The City of Riverside Public Utilities Department (RPU) and Southern California Edison (SCE) are proposing to construct and operate the Riverside Transmission Reliability Project (RTRP or Proposed Project) in the Cities of Riverside, Norco, and Jurupa Valley. The major components of the RTRP are a new 230 kilovolt (kV) overhead transmission line, new 69 kV overhead subtransmission lines, two new substations, and upgrades at four existing 69 kV substations. The new 230 kV transmission line would interconnect to an existing SCE 230 kV transmission line. This executive summary identifies why an Environmental Impact Report (EIR) was prepared, describes the Proposed Project and its location, describes purpose and need for the Proposed Project, and summarizes the environmental impacts of the Proposed Project.

### **ES.4 PROJECT CHANGES**

**RIVERSIDE TRANSMISSION RELIABILITY PROJECT**

FIGURE ES-1. PROPOSED PROJECT (REVISED)

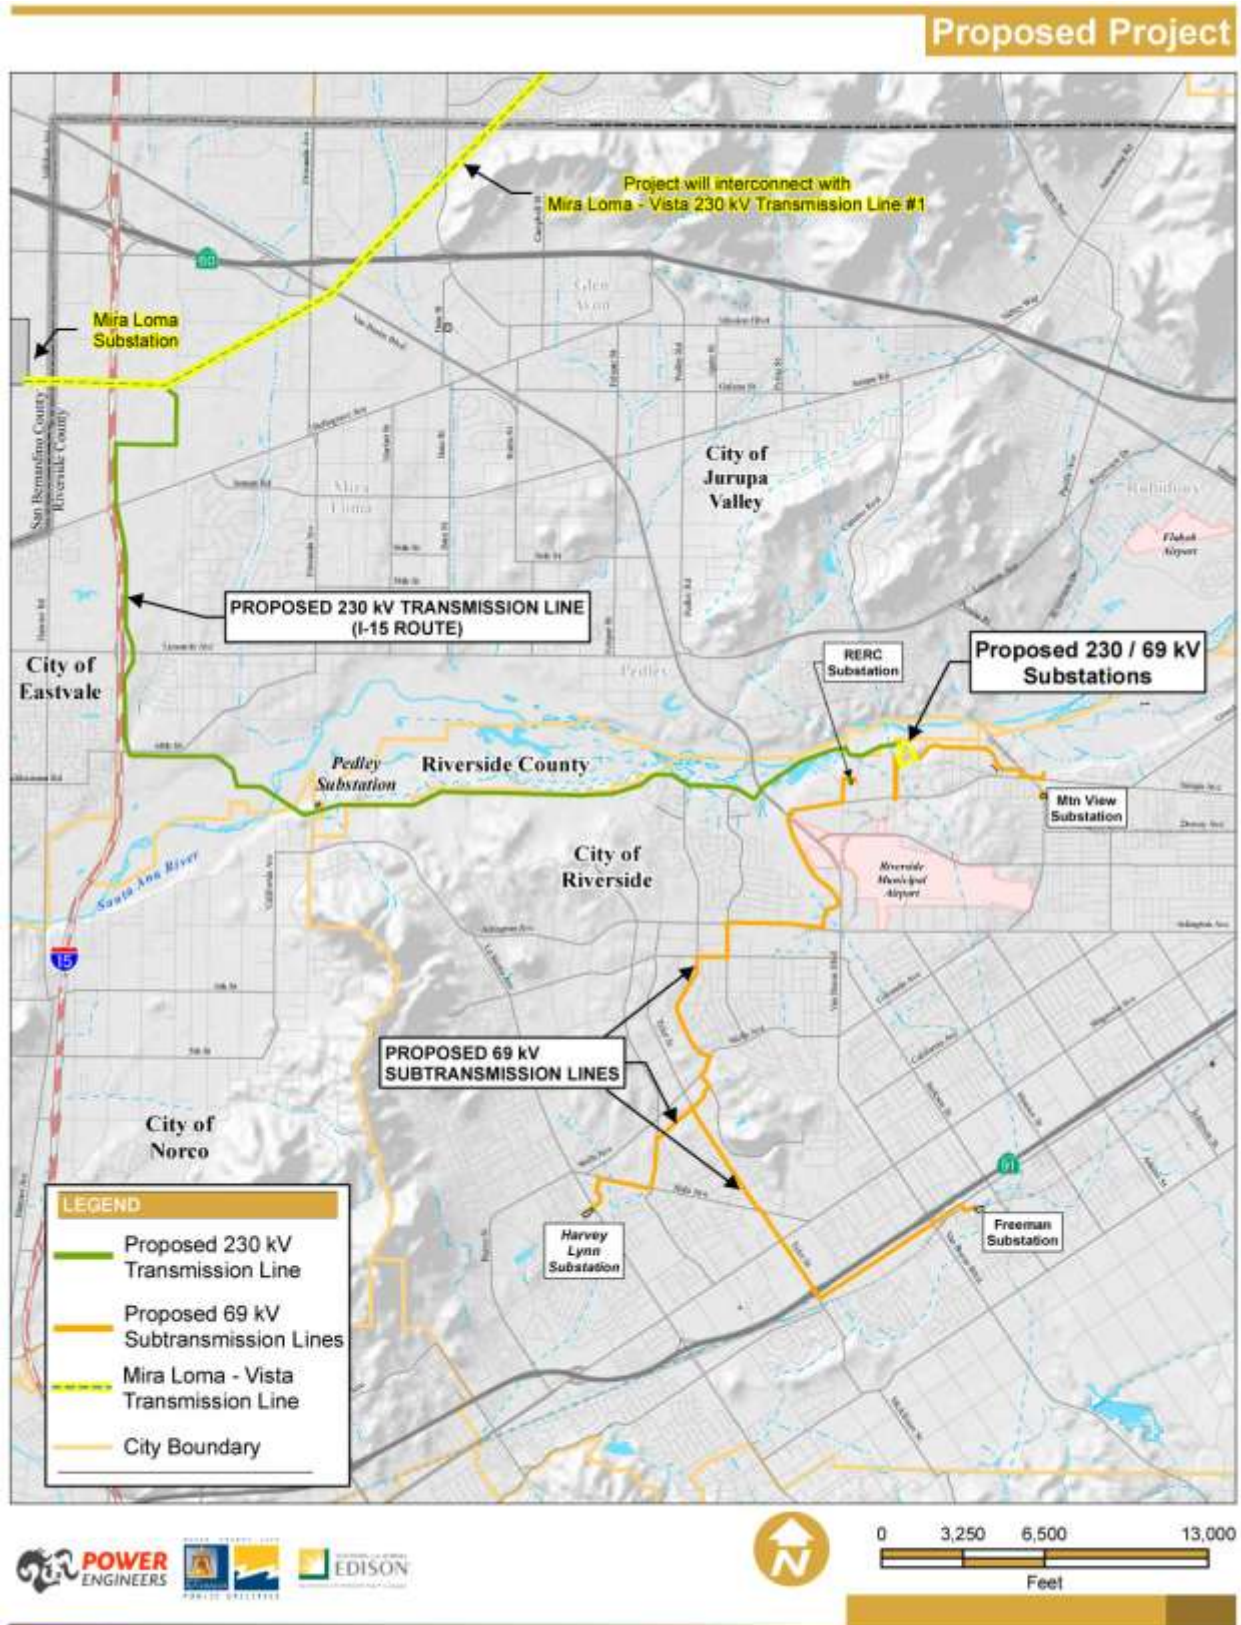
- The 230 kV transmission line's route has been modified to avoid the Vernola Marketplace parking lot by following I-15 roughly south and to the east of the California Department of Transportation's right-of-way. Additionally, the route along the Goose Creek Golf Club and Santa Ana River crossing has been slightly modified to utilize one double-circuit structure on each side of the river, instead of the previously presented two

single-circuit structures. Finally, the route's path near the City of Riverside Water Quality Control Plant has been shifted to the north side of the plant to reduce potential conflicts with current operations and possible future development at the plant. These routing changes are described in Section 2.3.1 in Chapter 2.

- The 69 kV subtransmission line will be placed underground in Segment A of the Riverside Energy Resource Center to Harvey Lynn/Freeman route in order to reduce potentially significant aircraft hazard and inconsistency with the Riverside County Airport Land Use Consistency Plan, as described in Section 2.3.2 in Chapter 2.

These changes are reflected in Figure ES-1.
